THE YANKEE ATOMIC ELECTRIC COMPANY

YANKEE NUCLEAR POWER STATION

AMENDMENT TO FACILITY OPERATING LICENSE

Amendment No. 77
License No. DPR-3

Figure 3.1-1

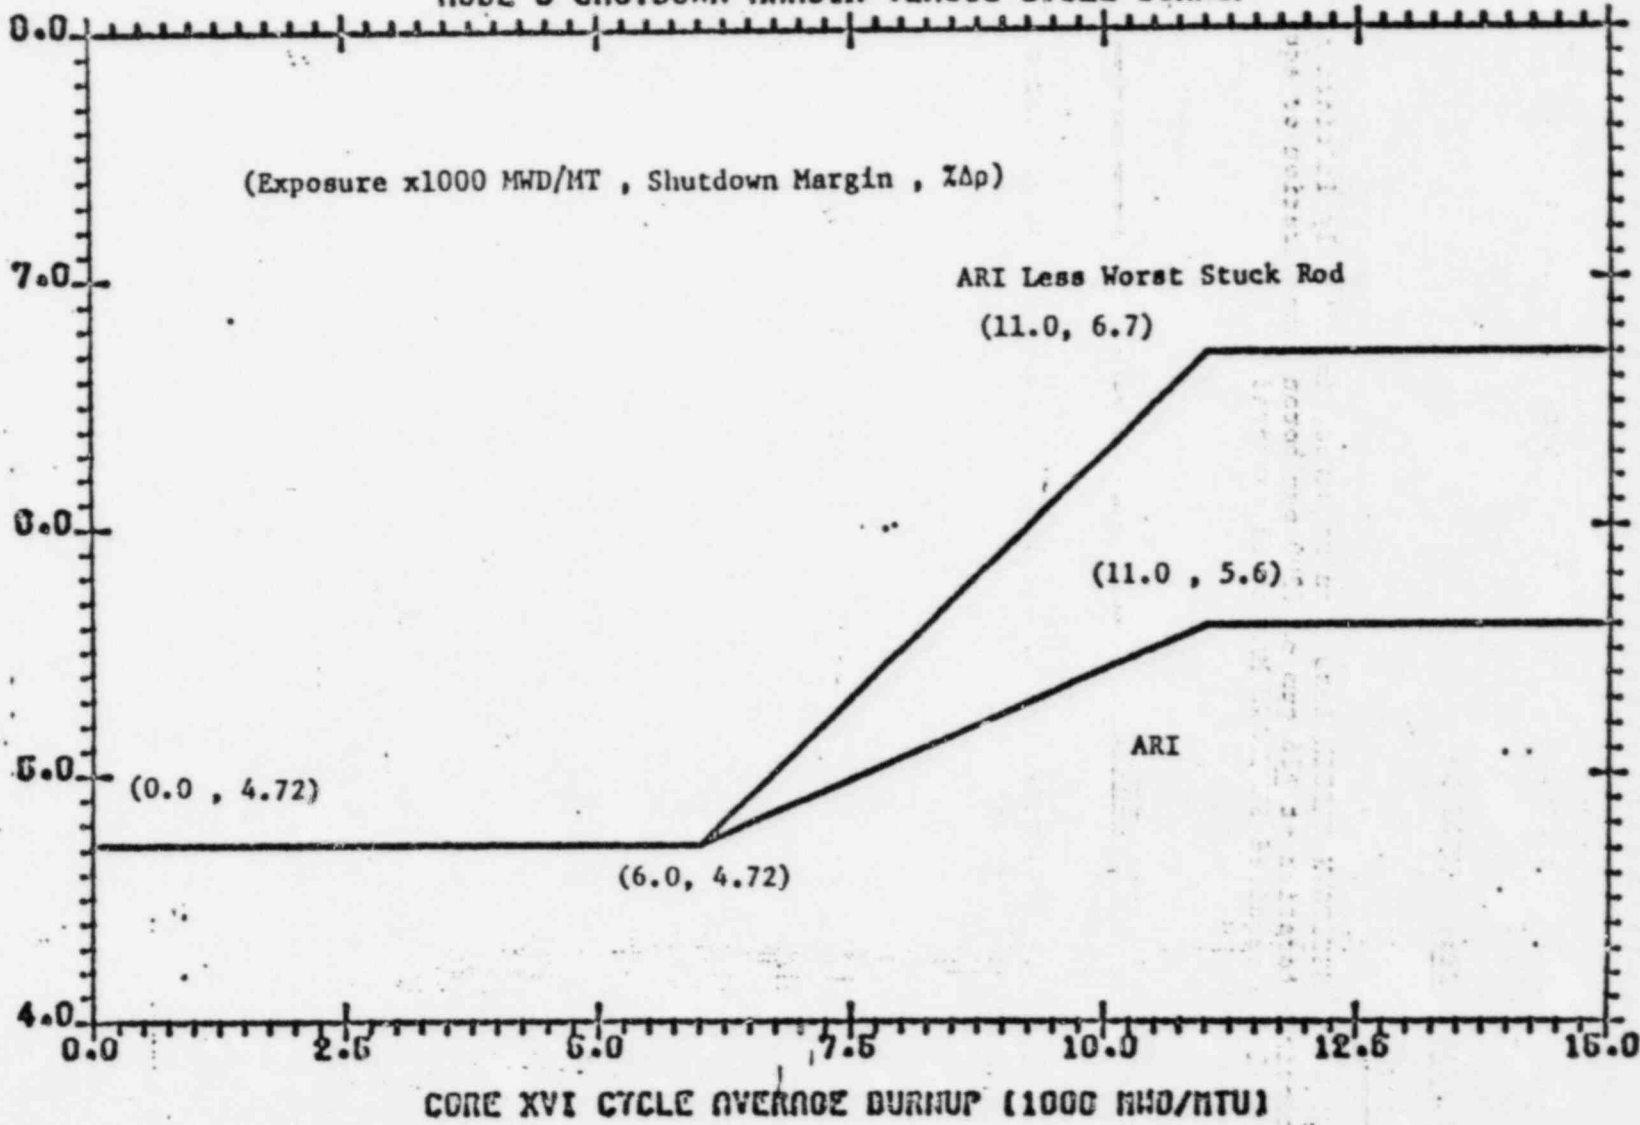
3.1.1.1.2 The shutdown margin shall be determined from Figure 3.1-1 for main coolant average temperatures above 490°F. Shutdown margin for $T_{avg} \leq 450$ is 4.72% $\Delta k/k$. The shutdown margin requirement is a linear function between 450°F and 490°F.

FIGURE 3.1-2

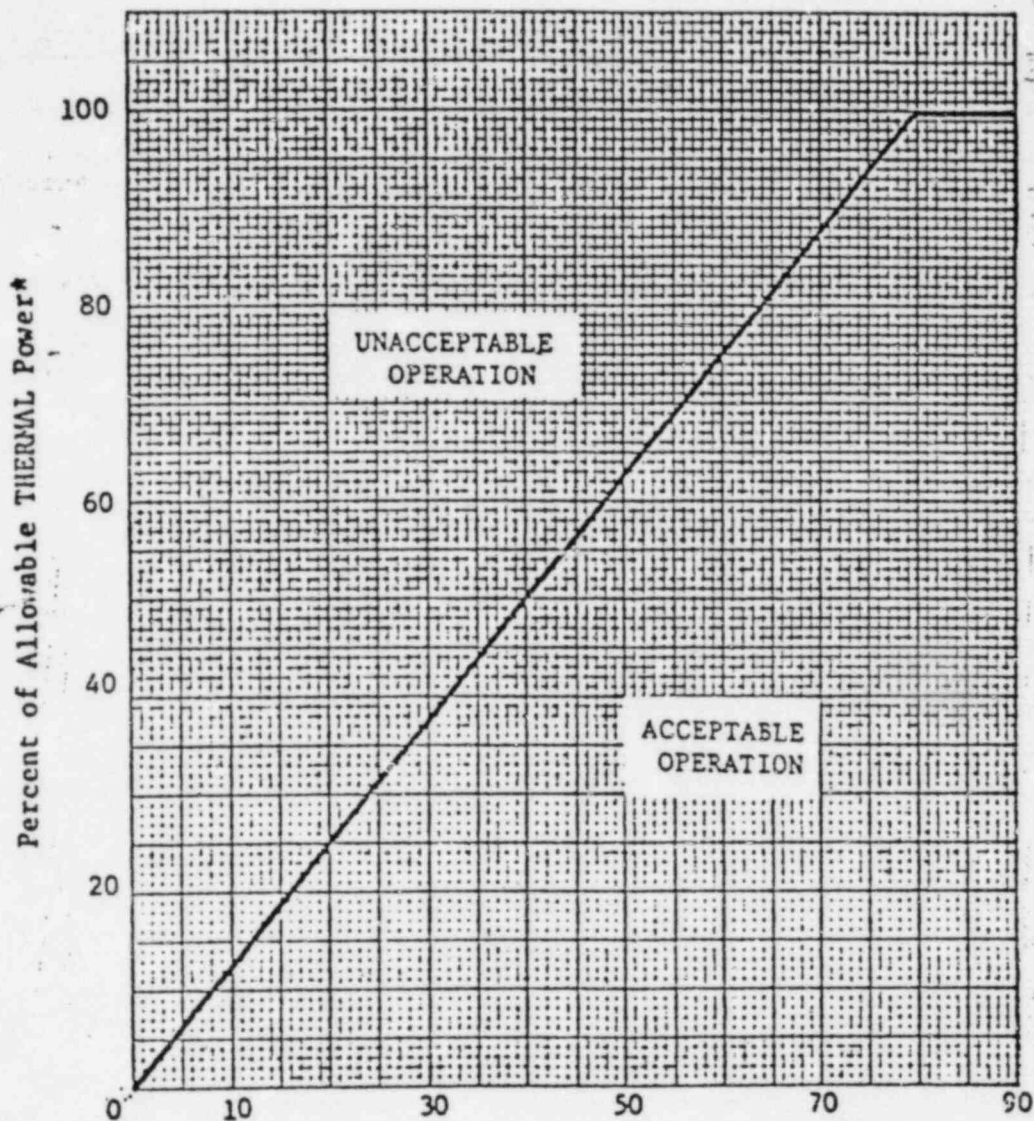
3.1:3.5 The control groups shall be limited in physical insertion as shown in Figure 3.1-2.

Figure 3.2-1

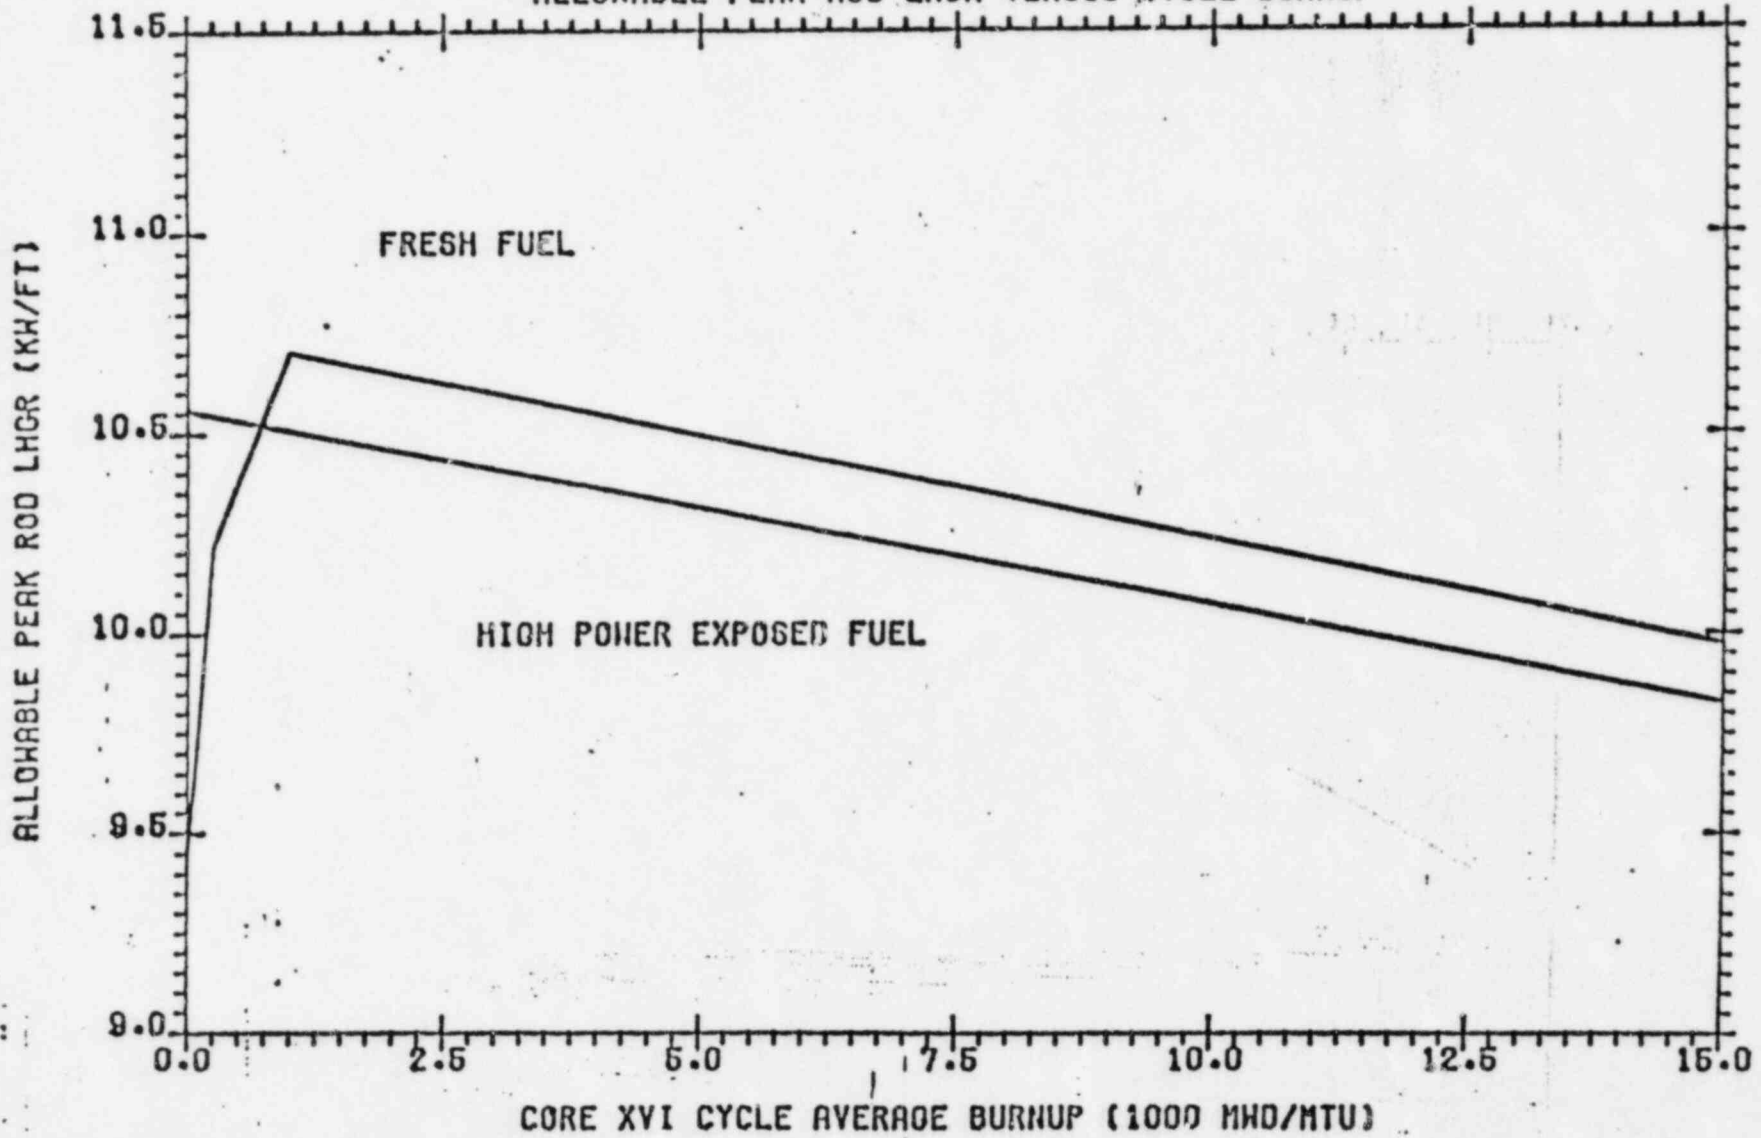
YANKEE ROWE CORE XVI
ALLOWABLE PEAK ROD LHGR VERSUS CYCLE BURNUP

Figure 3.2-3

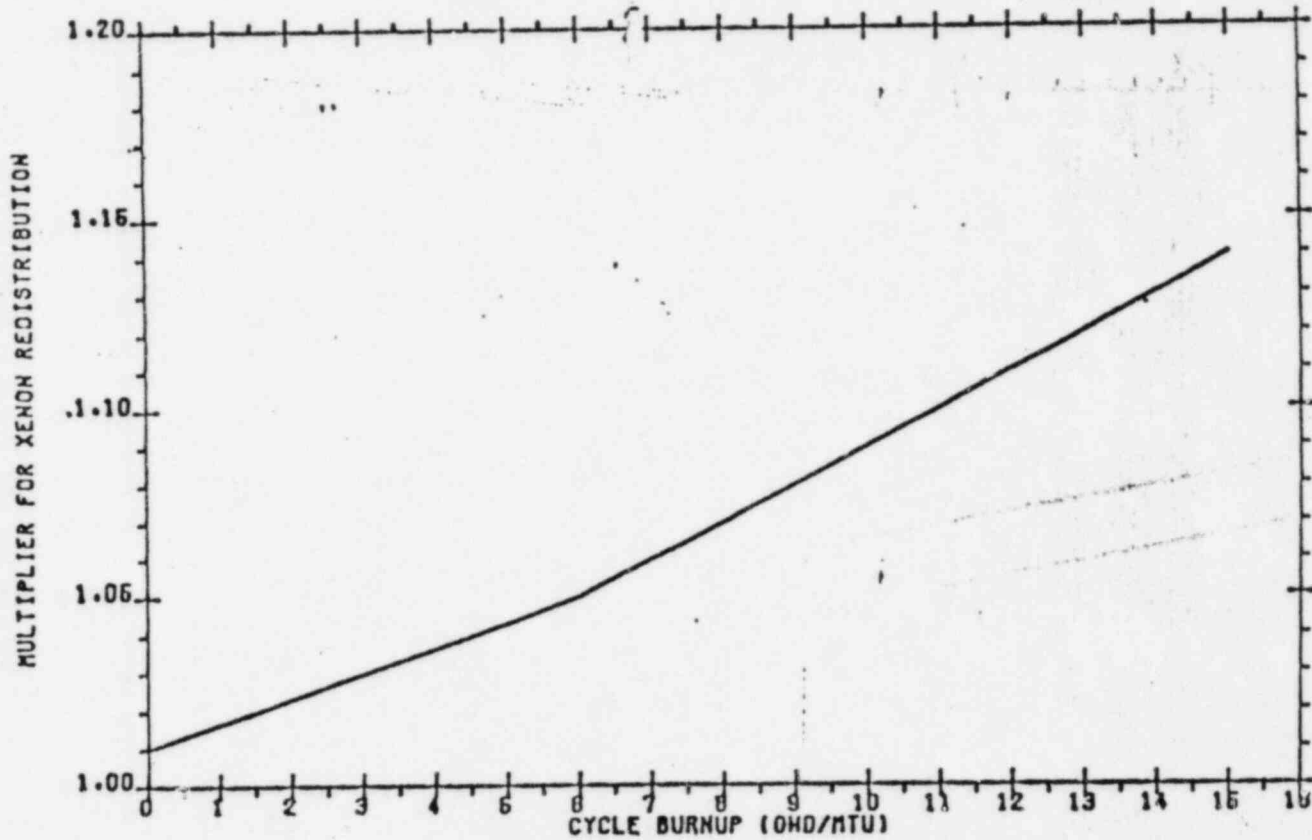
Multiplier for Xenon Redistribution as a Function of Exposure

Figure 3.2-4
Multiplier for Reduced Power as a Function of Exposure

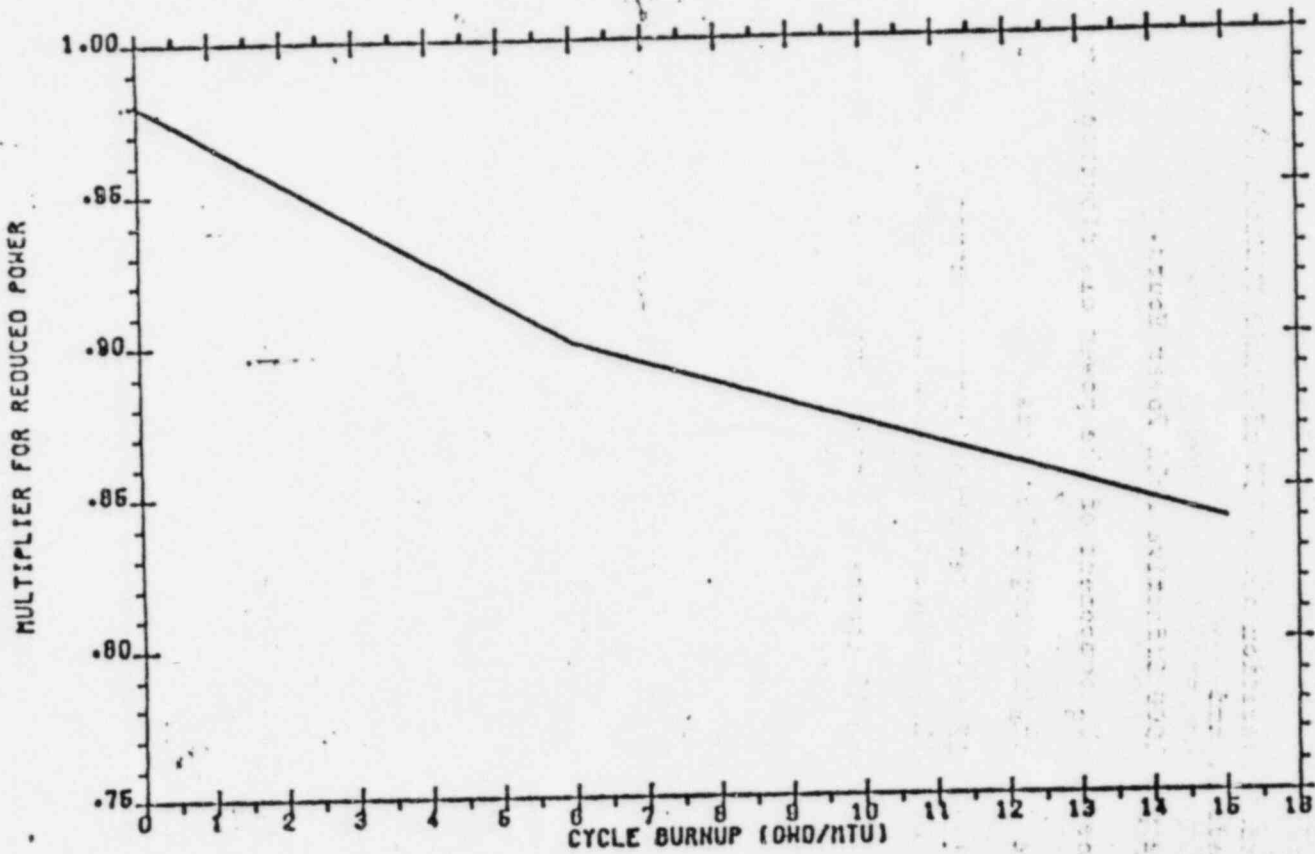
Reduced power = allowable fraction of full power times multiplier given in Figure 3.2-4.
